MONTGOMERY COUNTY PLANNING DEPARTMENT
THE MARYLAND-NATIONAL CAPITAL PARK AND PLANNING COMMISSION

DATE: November 3, 2008

SUBJECT: **DEVELOPMENT PLAN AMENDMENT NO: 08-2: THOMAS BUILDING.**
Request by Stabler 1848, LLC, for amendment of the Schematic development plan approved in Local Map Amendment G-627, located at 900 Olney Sandy Spring Road, Sandy Spring, consisting of 91,000 square feet of total floor area within the total gross tract area of 4.84 acres (Parcel A Sandy Spring Subdivision, Lot 1, Earnshaw Subdivision and unrecorded Parcel 426), in the O-M zone.

SCHEMATIC DEVELOPMENT PLAN

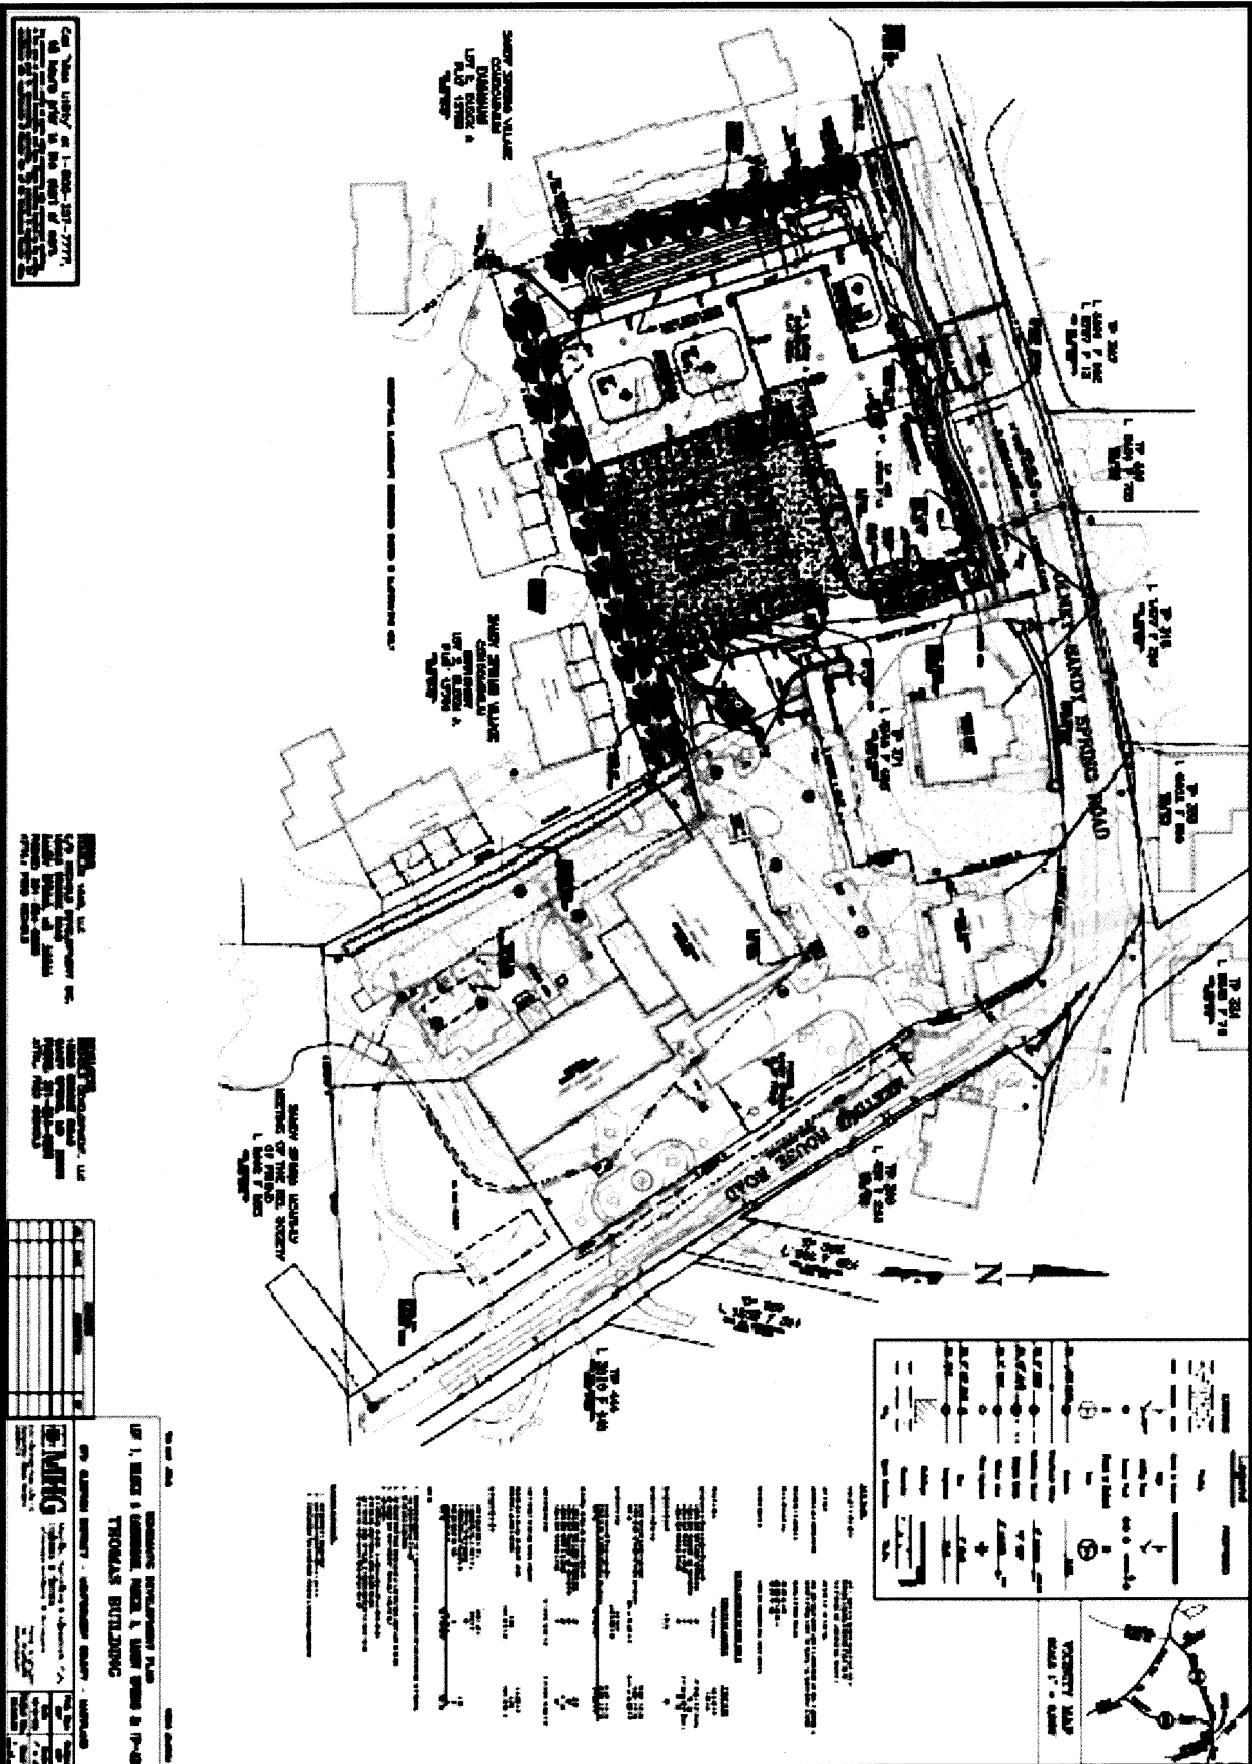
The proposed amended schematic development plan shows a total of 302 parking spaces. This total includes 6 motorcycle spaces, and 296 automobile spaces (including 8 handicap spaces). The number of motorcycle and bicycle spaces should be calculated in accordance with Section 59-E-2.3 and should not be counted to satisfy the requirement for automobile parking spaces. Moreover, the applicant should provide the required bicycle spaces per Section 59-E-2.3.

Staff recommends that at the time of site plan review, the adequacy of parking spaces and provision of bicycle spaces for the project be addressed.

PRELIMINARY FOREST CONSERVATION PLAN

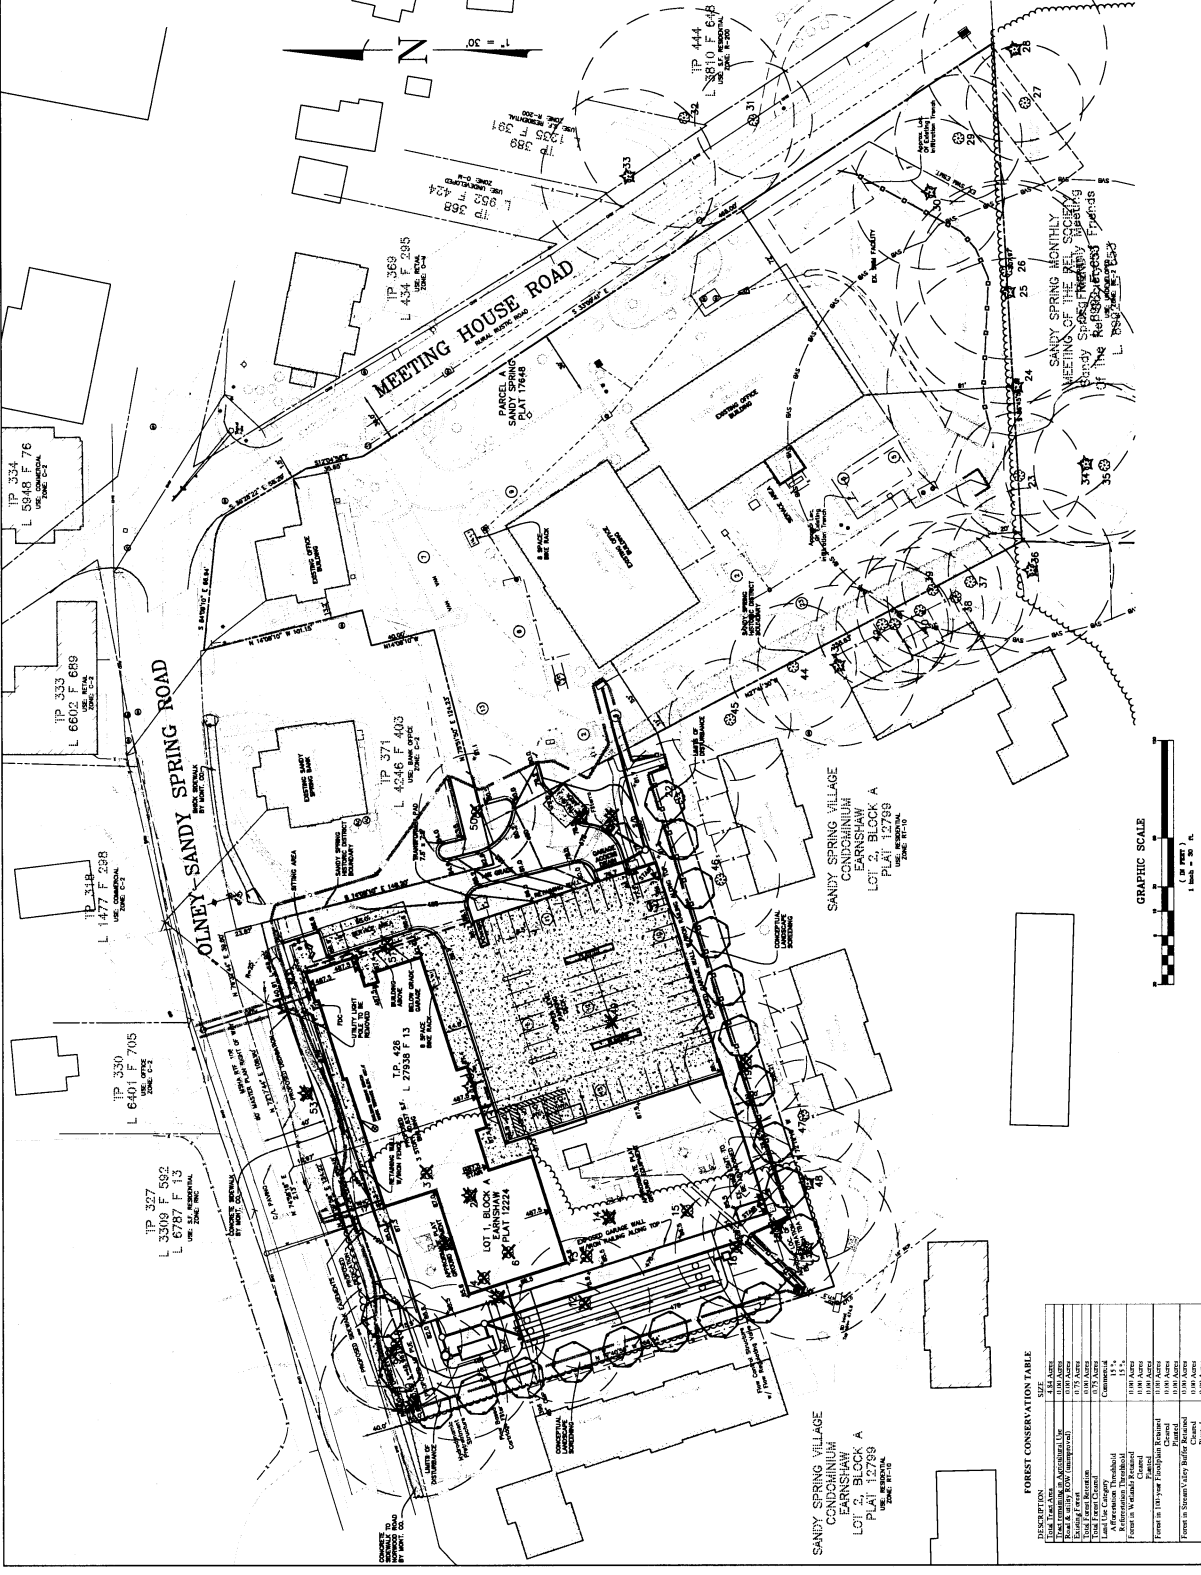
The site is not subject to a previously approved forest conservation plan; therefore the applicant submitted a preliminary forest conservation plan as part of the Development Plan Amendment. The subject site includes 0.75 acres of existing forest and the applicant is proposing to remove all the forest generating a forest planting requirement of 1.27 acres. The applicant proposes to meet the planting requirements through an off-site forest mitigation bank.

The onsite stream valley buffer is located on the east side of the property and is already developed under the original Schematic development plan. The existing development in this area includes part of a stormwater management facility, surface parking, and a portion of a three story building; therefore placing this area into easement is not feasible.

Environmental Planning staff recommends approval of the Development Plan Amendment and the preliminary forest conservation plan with conditions. The plan complies with Section 22A of the Montgomery County Code and the M-NCPPC Environmental Guidelines.
